APPLICATION NO.	FILING DATE	FIRST NAMED INVENTOR	ATTORNEY DOCKET NO.	CONFIRMATION NO.
10/724,964	12/01/2003	Lee J. Brown	1613	3037

Office Action Summary

This is a first office action for serial number 10/724964, entitled End Cap for Rain Gutters, filed on December 1, 2003.

FIG. 5

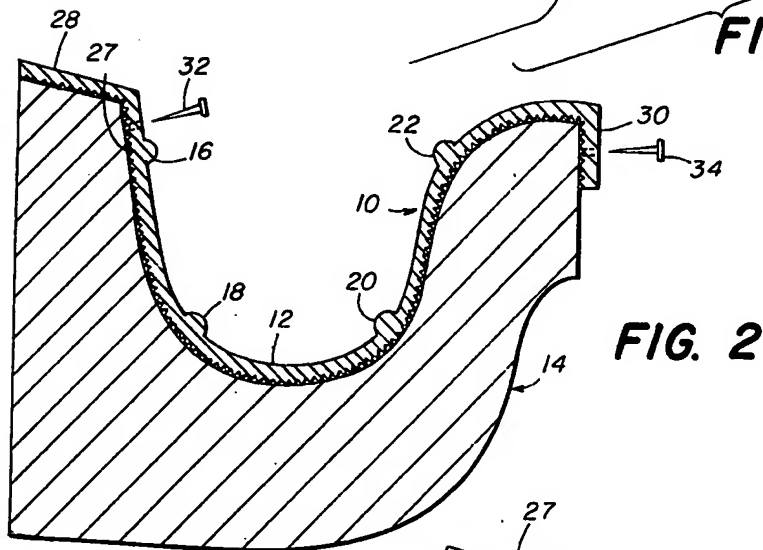
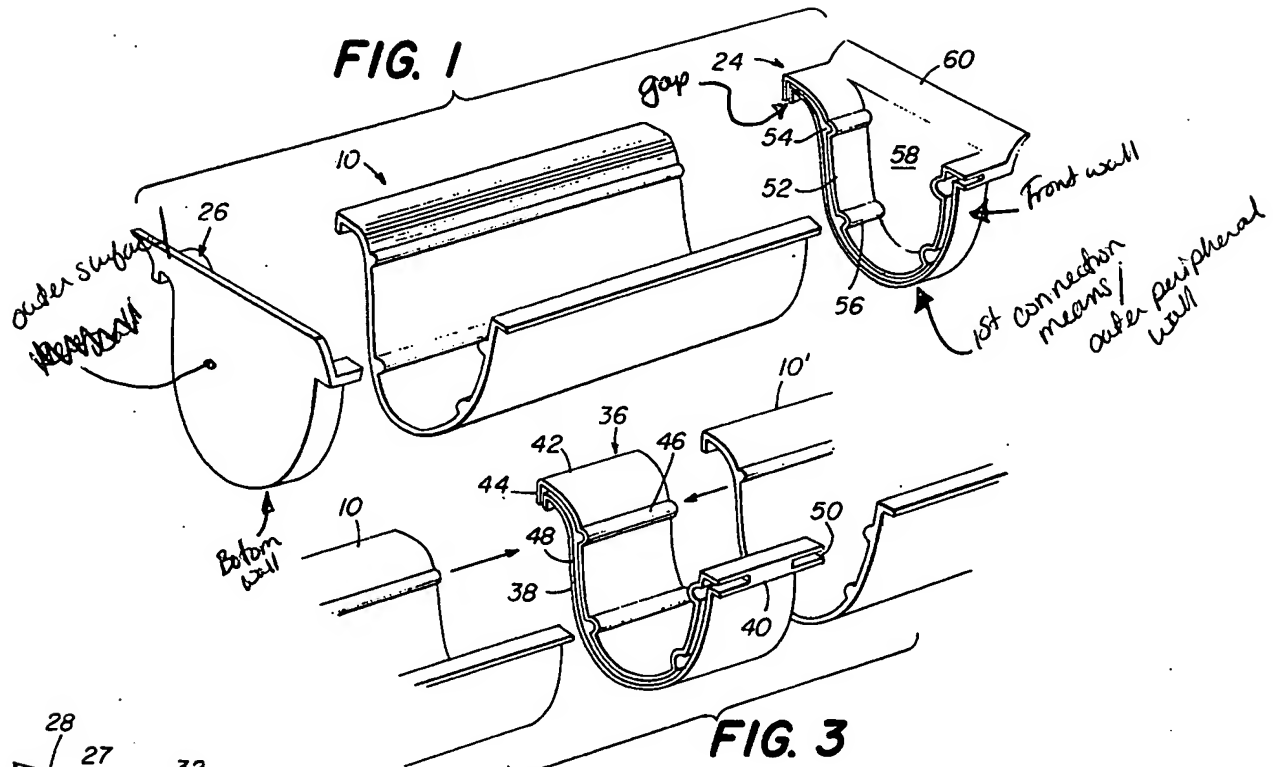
Carreiro discloses the claimed invention a rain gutter end cap (24, 26) comprising a) an end panel (60) having an inner surface (58) and an outer surface (attached figure 1) and including a perimeter having a predetermined shape (figure 1); b) first connection means (attached figure 1) carried by the end panel; and c) second connection means

(52) carried by the end panel; the first connection means (attached figure 1) includes an outer peripheral wall (attached figure 1 and at 60) extending laterally outwardly from the inner face (58) of the end panel and an inner peripheral wall (at 52) extending laterally outwardly from the inner face (58) of the end panel and positioned inwardly of the outer peripheral wall to define therebetween a connection slot (54); the outer peripheral wall defines an end cap top wall (where 60 points to), an end cap rear wall (attached figure 1), an end cap bottom wall (attached figure 1), and an end cap front wall (attached figure 1); the outer peripheral wall is substantially continuous (figure 1); the outer peripheral wall (attached figure 1) and the inner peripheral wall (at 52) are substantially perpendicular to the end panel inner surface (58); the outer peripheral wall includes a gap (attached figure 1) between the end cap top wall (at 60) and the end cap rear wall (attached figure 1); the inner peripheral wall (at 52) extends substantially along and parallel to the end cap front wall (attached figure 1), the end cap bottom wall, and the end cap rear wall (where 24 points to); wherein the inner peripheral wall (at 52) extends along the end cap rear wall (where 24 points to) from a point between the end cap top wall (at 60) and the end cap bottom wall (attached figure 1), along the end cap bottom wall, and along the end cap front wall to a point between the end cap top wall (at 60) and the end cap bottom wall (attached figure 1); the second connection means (52) includes at least one aperture (54) in the end panel; the second connection means (52) includes a projection (56) extending outwardly from the end panel inner surface (58).

Claim 6 is rejected under 35 U.S.C. 103(a) as being unpatentable over Carreiro.

Carreiro discloses the claimed invention as stated above in claim 1, except for the inner peripheral wall extends from the inner surface a greater distance than the outer peripheral wall. It would have been an obvious matter of design choice to provide
